Subject: St. Lucie Units 1 and 2  
Docket Nos. 50-335 and 50-389  
RAI Reply - License Amendment Request  
Containment Vacuum GOTHIC Analyses and Conforming Changes

Request for Additional Information MF6980/1-SCVB-01 through 08 Responses

UFSAR FIGURE 6.2-56

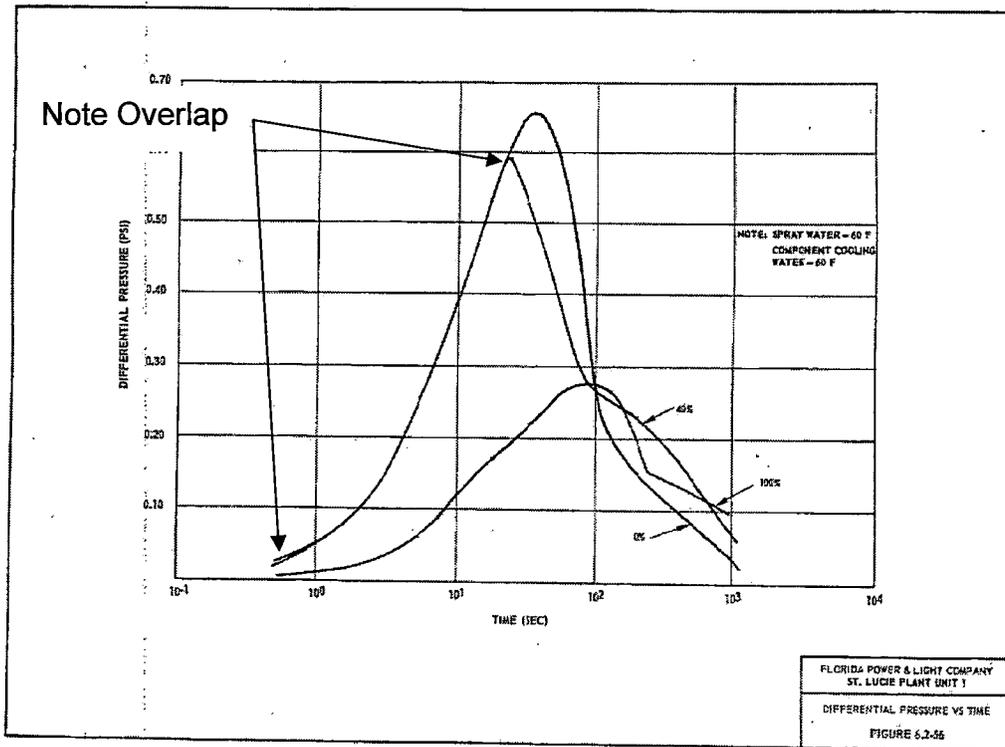
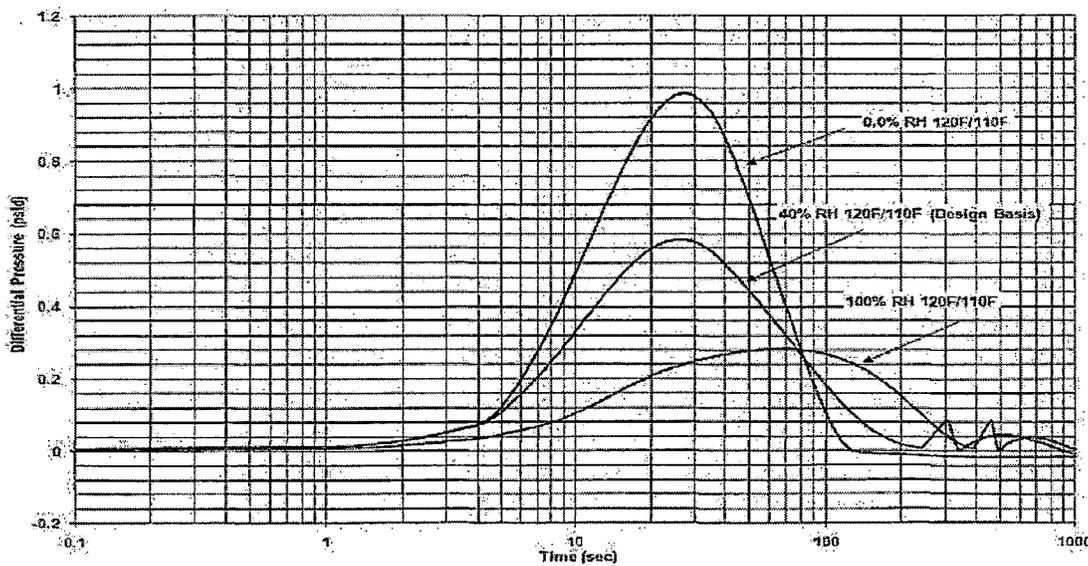
Explain further the conclusion that for Unit 1 the GOTHIC benchmarking results appear more reasonable and conservative than the UFSAR's results.

As shown in the table below, the maximum values of DP(Annulus-Cont.) and DP(Atm.-Annulus) predicted by GOTHIC are in good agreement (i.e. less than  $\pm 6\%$ ) with the UFSAR values except the maximum value of DP (Annulus-Cont.) for Case A (i.e.  $\sim 49\%$ ).

The comparison of UFSAR Figure 6.2-56 and the chart of GOTHIC results below shows some deviation in the trend of differential pressure transient from the annulus to the containment for Case A. Considering that the lower initial containment relative humidity condition should lead to a faster and steeper depressurization in the containment, it can be concluded that GOTHIC prediction seems more reasonable and conservative. Note that the overlapping of the two differential pressure curves of Cases A and B up to approximately 30 seconds as shown in UFSAR Figure 6.2-56 seems less realistic than the GOTHIC results.
